Br. art. 1888 600 150 i 1888 998 101

Spojke s ventiliranim kućištem, torzijskim oprugama i sinteriranim oblogama (br. art. 1888 600 150 i 1888 998 101) zamjenjuju spojke (br. art. 1888 600 117, 1888 600 119 i 1888 634 006).

sl. 2: Spojka, promijenjena konstrukcija

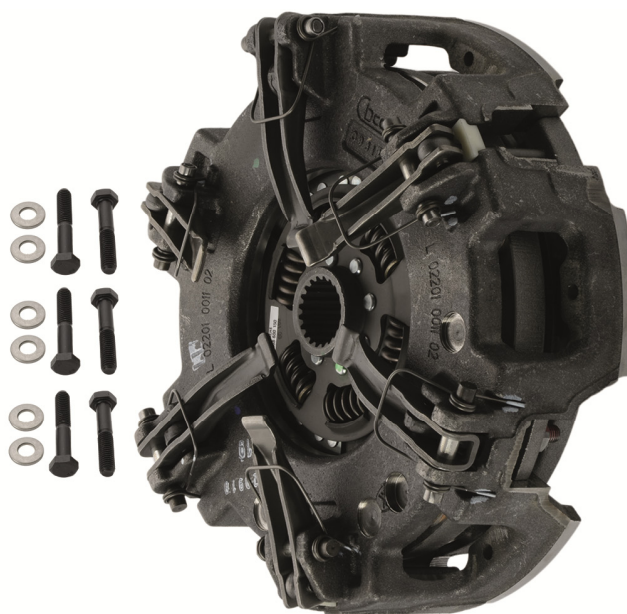
Spojka s ventiliranim kućištem može se ugraditi bez modifikacija zamašnjaka.
Komplet od šest vijaka M8x1,25x45 sadržan je u isporuci.
